Rezoning Transportation Analysis

Petition Number: 2018-018

From: CDOT Land Development Section **Reviewer:** Carlos Alzate
calzate@charlottenc.gov
 704-432-0672

| Revision Log: | Date | Description |
|---------------|----------|--------------|
| | 03-26-18 | First Review |

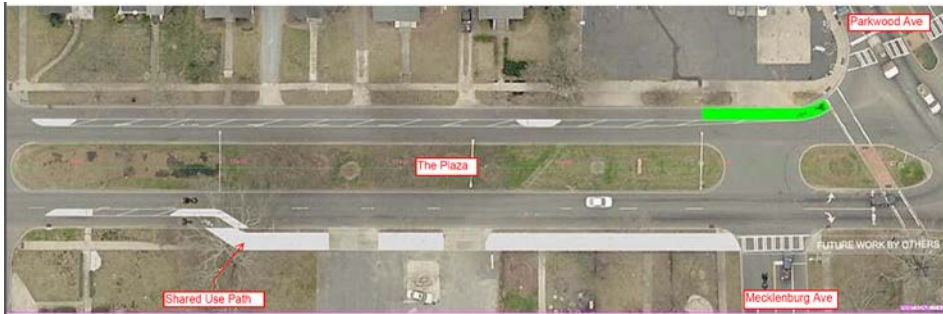
1. **Curbline** The proposed zoning district has a setback measured from back of the existing or proposed future curbline. The location of the future back of curb:
 - a. **The Plaza:** Existing back of curb is in the correct location
 - b. **Belvedere Av:** Existing back of curb is in the correct location
 - c. **Thurmond PI:** Existing back of curb is in the correct location
